Board of Architectural Review

DATE: January 18, 2017
TO: Board of Architectural Review Chair and Members
THROUGH: Jason Sutphin, Community Development Division Chief *JDS*
FROM: Tommy Scibilia, BAR Liaison *TS*
SUBJECT: **Boulevard Marketplace Pad Site**

1. Case Number: BAR-17010016
2. Address: 10120 Fairfax Boulevard
3. Request: Construct a new commercial building and site improvements
4. Applicant: JDC Boulevard, LLC (Jay Donegan)
5. Applicant's Representative: Francis X. Watkins
6. Status of Representative: Agent
7. Zoning: CR Commercial Retail

CONCEPTUAL LANDSCAPE PLAN
10120 FAIRFAX BOULEVARD
BOULEVARD MARKETPLACE
FAIRFAX COUNTY, VIRGINIA

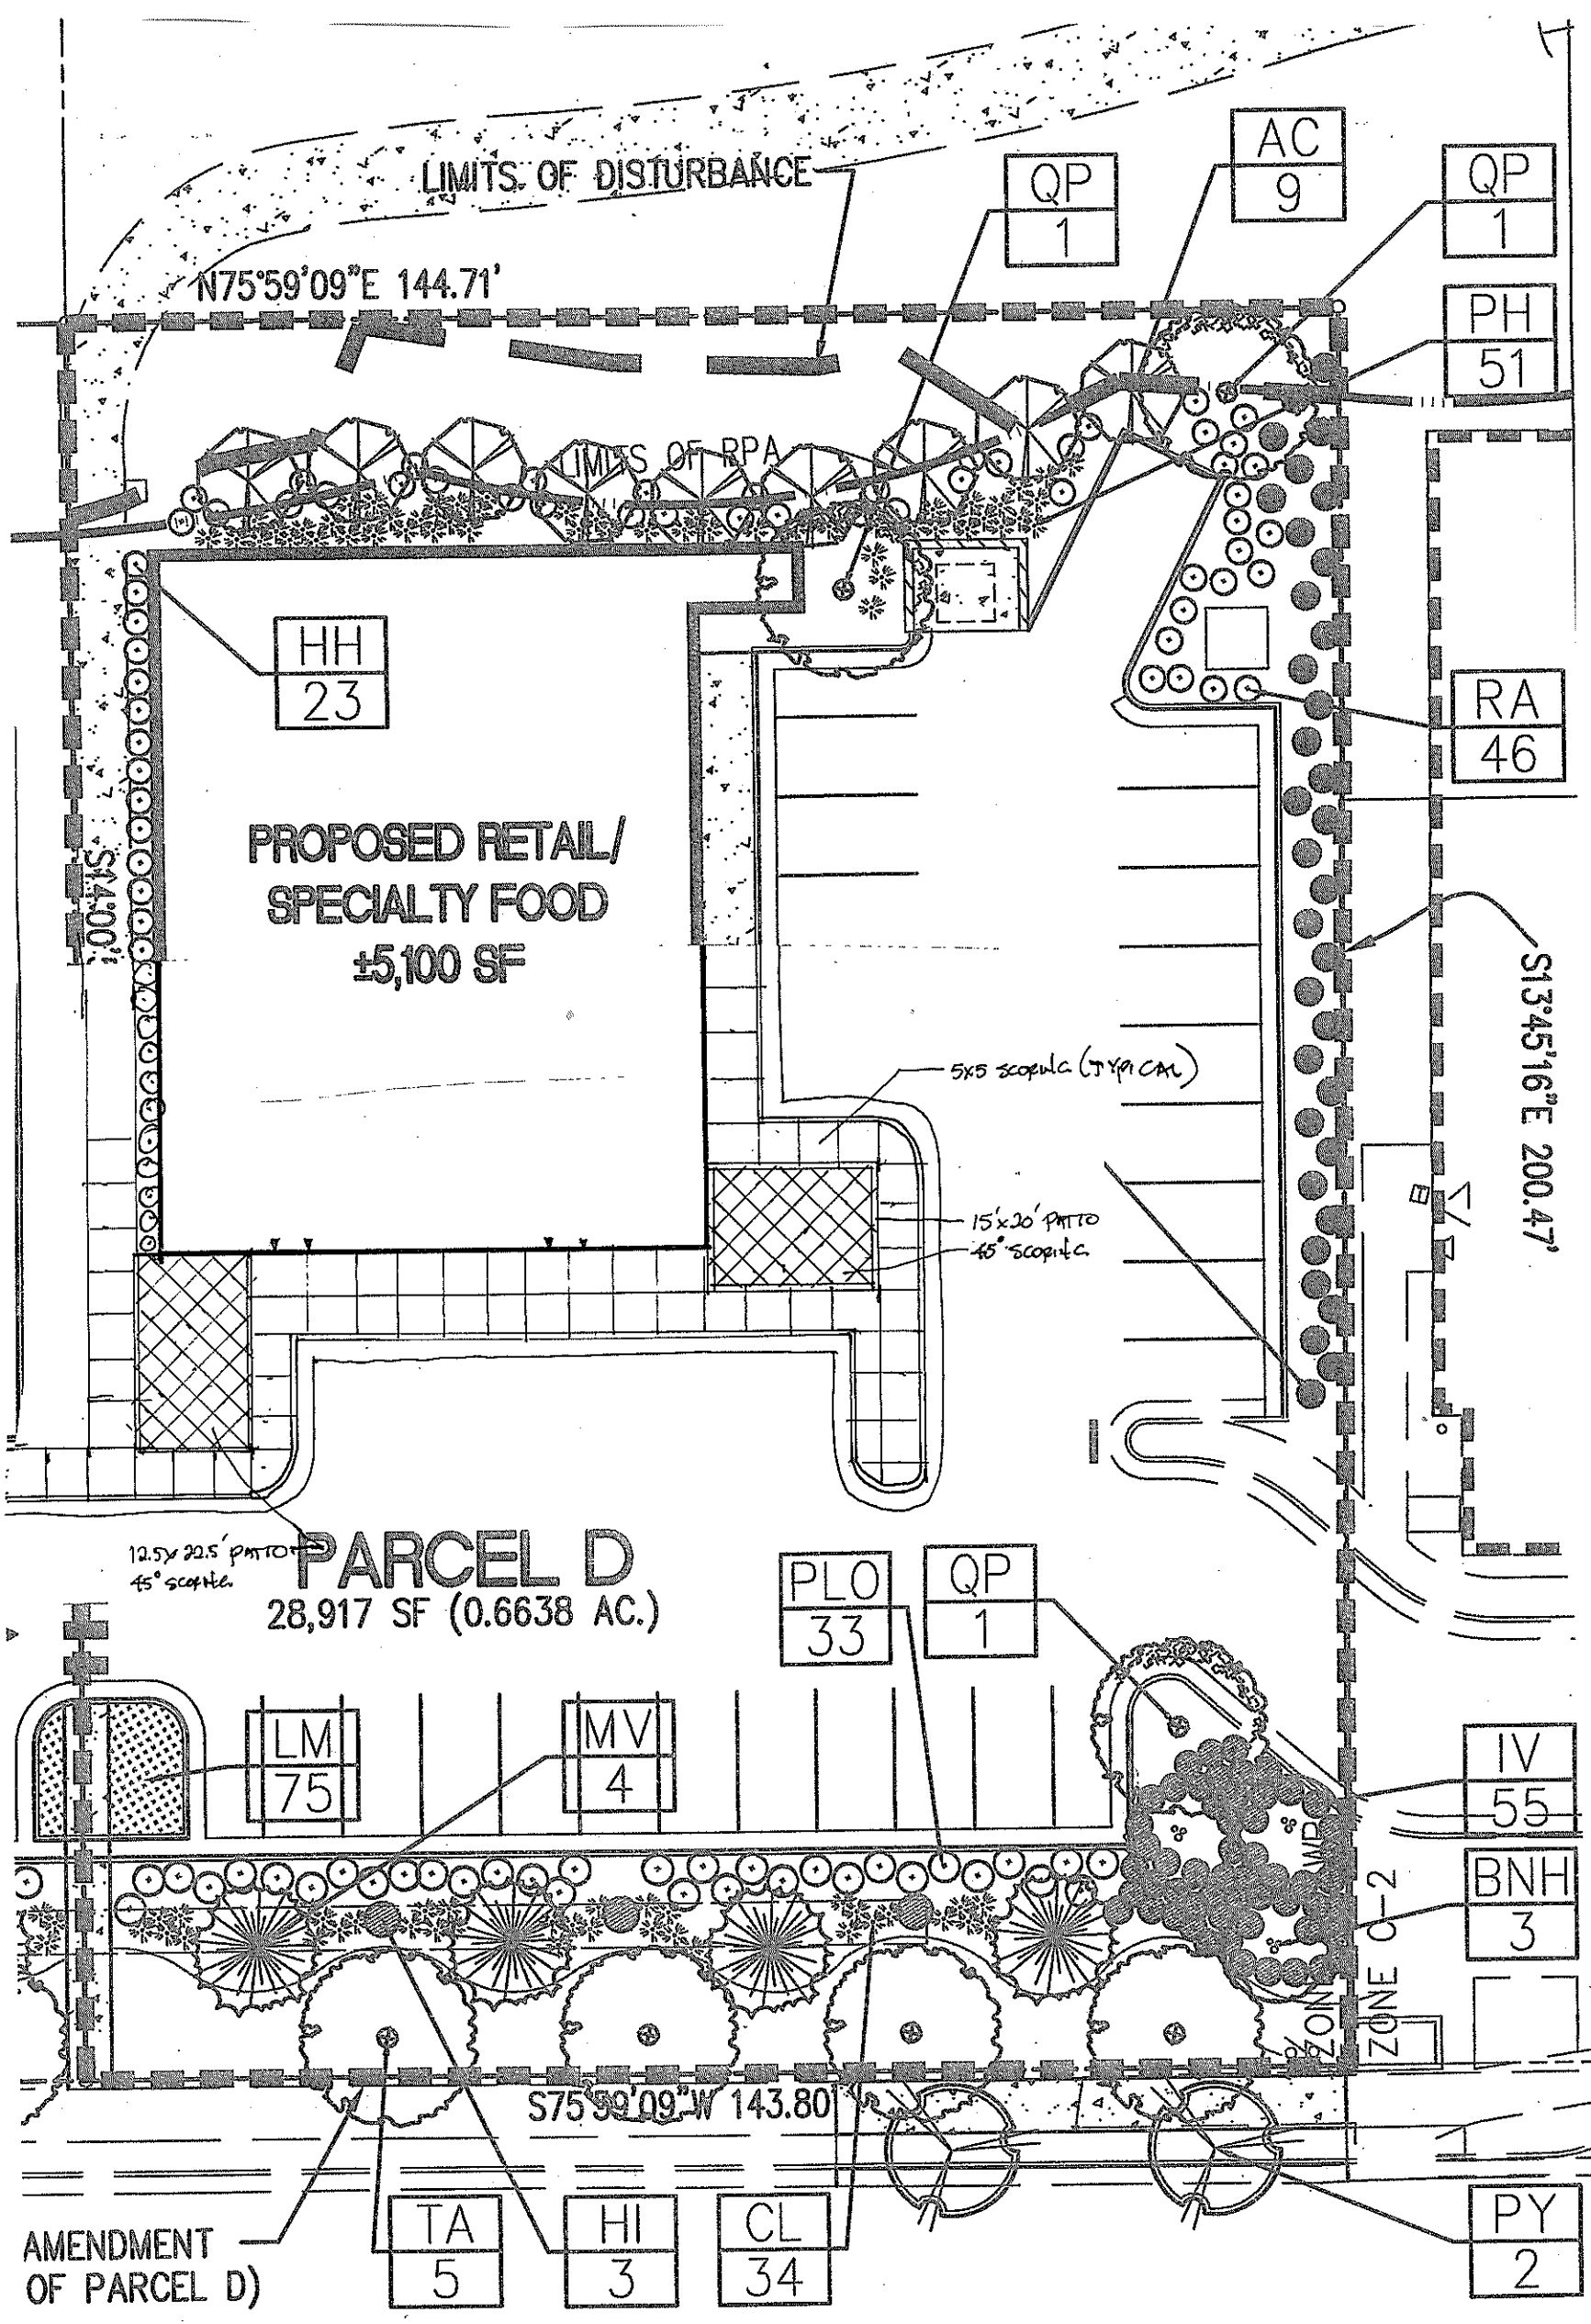
A bed of decorative trees, shrubs, and perennials is shown in the landscape plan along the south property line beside the sidewalk on Fairfax Boulevard. These plantings are already in place as of the construction of the two existing Boulevard Marketplace buildings.

New plantings include additional shrubs along the east property line beside the Patient First building, shrubs surrounding an existing transformer, decorative serviceberry trees along the rear of the proposed building and parking area to the north accompanied by ground plantings of shrubs and perennials, and a row of shrubs in a narrow strip of landscaping between the west façade of the

proposed building and the concrete walkway that ties into the existing trail to the north (see Attachment 2).

The landscaping that already exists along the southern property line provides an attractive aesthetic along Fairfax Boulevard, contributes to the “boulevard effect” mentioned, and helps screen the parking lot.

The proposed enclosure will effectively screen the proposed dumpster from view, and the proposed landscaping should provide additional cover for the transformer, per the requirements zoning ordinance and Community Appearance Plan.

Front Elevation
1/16"=1'-0"

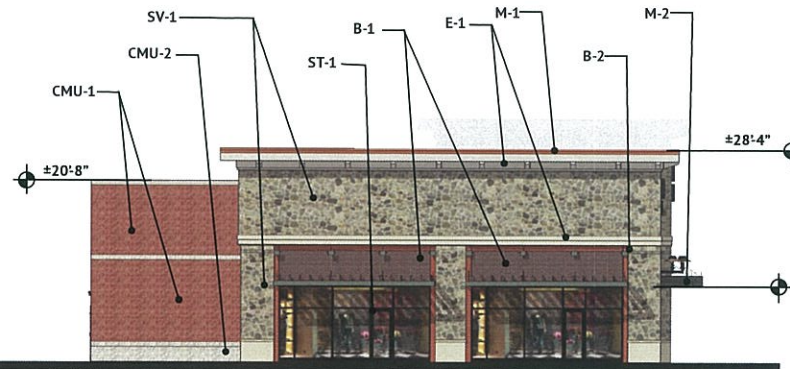
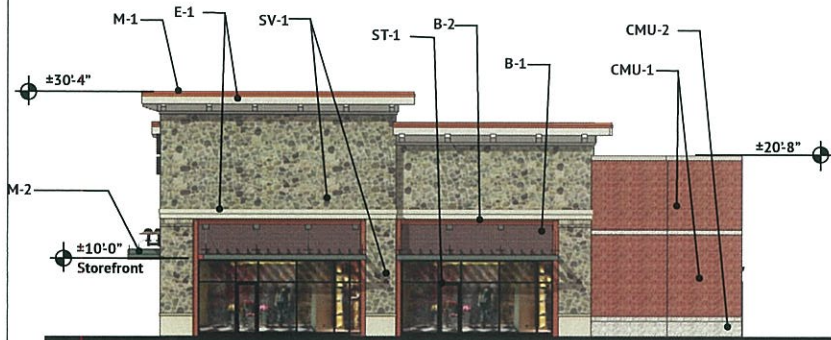
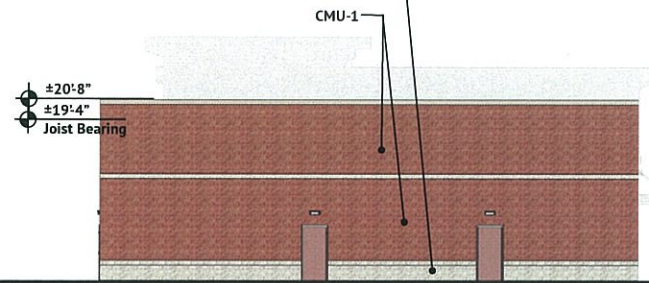
The building form is generally rectangular with a small piece of the building jutting out from the northeast corner. The building's profile is proposed to be two feet higher on the east tenant side, adding a slight vertical dimension to this edge of the shopping center. A 9'4" parapet is proposed around the front tenant spaces, effectively shielding the rooftop mechanical units from view in the right-of-way. Both tenant spaces would be faced in grey stone veneer with sand colored mortar, and would have ample floor to ceiling storefront windows in a black finish on the south, east, and west elevations. The rear portion of the building would be Betco Supreme *Williamsburg Red* split-face CMU block with two decorative bands of Betco Supreme *Light Khaki* split-face CMU. The service entrances to the two tenant spaces would be located on the north elevation, while the main entrances to the tenant spaces would be on the south elevation facing Fairfax Boulevard. Above all storefront space would be suspended, flat, dark bronze awnings. Above these awnings would be fields of Taylor *Royal Salisbury* dark brown brick. A frame of Glen-Gery *Red Cliff* brick would surround the storefront, awnings, and dark brown brick fields. A strip of decorative white EIFS trim would wrap the stone veneer portions of the building, separating the framed storefront areas below from the field of stone veneer above, anticipated to be used as the sign band. The roofline would be defined by a flat white EIFS cornice capped with "champagne" colored metal coping. The entire base of the building from front to back would be the *Light Khaki* split-face CMU. A dumpster enclosure is proposed beside the northeast corner of the building off of the parking lot, and would match the existing dumpster enclosure on the west end of the Boulevard Marketplace shopping center, which is composed of reddish-brown split-face CMU and matching corrugated metal doors. Three wall-mounted, upward-cast, full cutoff decorative lighting fixtures are proposed beside the dark brick fields on the south elevation (see Attachment 3).

Rooftop mechanical units proposed would be successfully screened with the 9'4" parapet.

The proposed materials include two types of brick, CMU, and stone veneer, all of which staff finds appropriate.

The colors and material palette proposed are very neutral and tasteful, play off of the forested backdrop well, and are consistent with the materials and colors of the existing portion of the Boulevard Marketplace shopping Center.
